*Memorandum*

**To:** **The Planning Commission**
**From:** **Niall Connolly**
**Date:** **February 13, 2026**
**Re:** **Design Development Review for the River Park Expansion Project**

**Figure 2. Existing and Proposed vehicular entry and parking area**

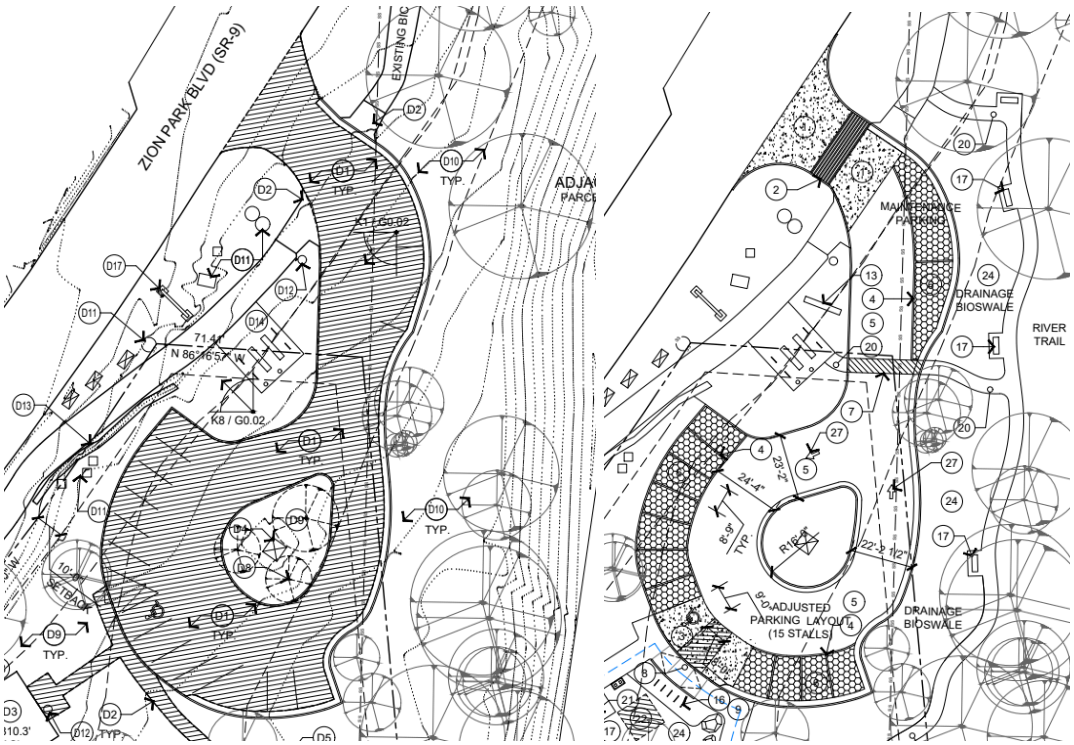
- Reconfiguring and resurfacing the vehicular entry and parking area. The size and shape of the paved area is not increasing, although the vegetated island in the middle of the turning circle is being slightly reduced in size.

**Figure 4. The River Park overlaid by the Special Flood Hazard and Erosion Hazard Zones.**

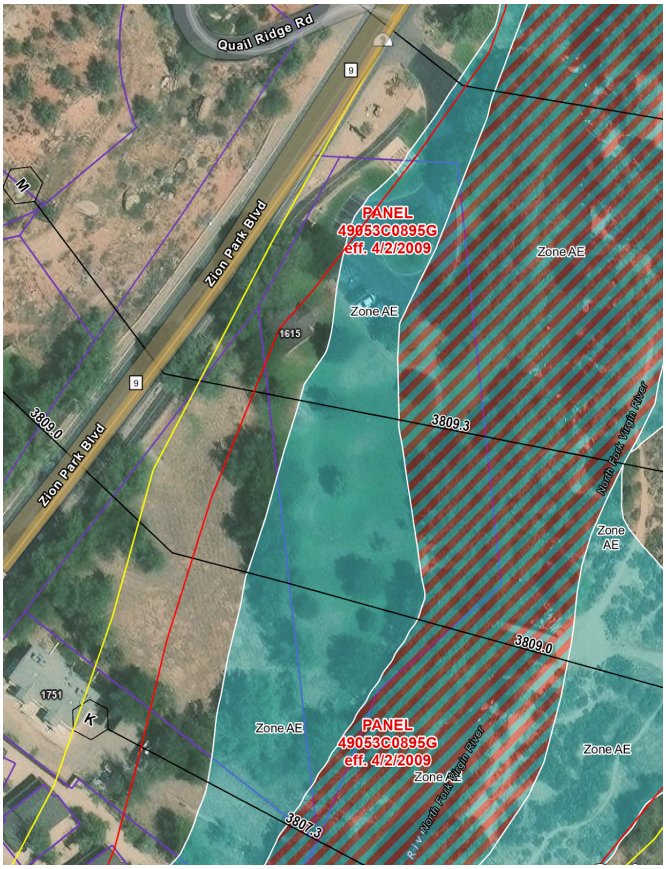
The River Park is partially within the Special Flood Hazard Area and the Erosion Hazard Zone. The design proposals are relatively light on the land, and so no significant impacts on the floodplain or erosion zone are anticipated. However, because some grading is proposed, an erosion hazard study has been submitted. Both an erosion hazard permit and a floodplain development permit will be required. No erosion protection (riprap etc) is proposed as part of this application.

The erosion hazard study and engineering drawings show some improvements that may be part of a future phase of development, but are not proposed at this time. These potential future phase improvements include a new restroom building and a river viewing platform. The Commission should note that permission for these improvements is not being sought at this time. The Commission should evaluate the application based only on the improvements proposed for the first phase of the project. The

Commission may wish to emphasize that any approval given includes only the phase one improvements and any additional future development must be submitted for additional review.
